PCI-SIG ENGINEERING CHANGE REQUEST

TITLE:	Add a second PCIe lane to Type 1216 SDIO Based LGA Module
DATE:	May 23, 2017
AFFECTED DOCUMENT:	PCI Express M.2 Specification, Revision 1.1
SPONSOR:	Jim Panian, Qualcomm Technologies Inc.

Change Figure 99, page 127, as follows:

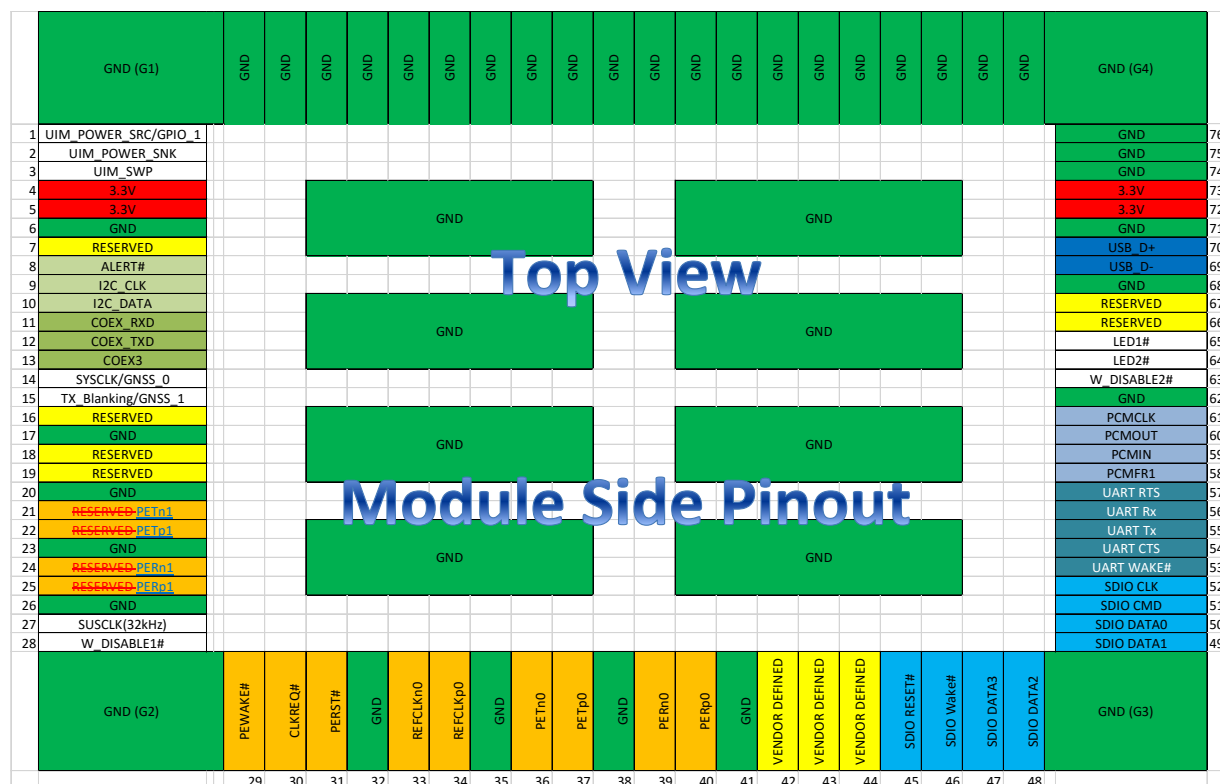
The M.2 Type 1216 Land Grid Array (LGA) Connectivity module is modified to add a second PCIe lane. Referring to Figure 99 on page 127:

Pad #	Current	New
21	Reserved	PETn1
22	Reserved	PETp1
24	Reserved	PERn1
25	Reserved	PERp1
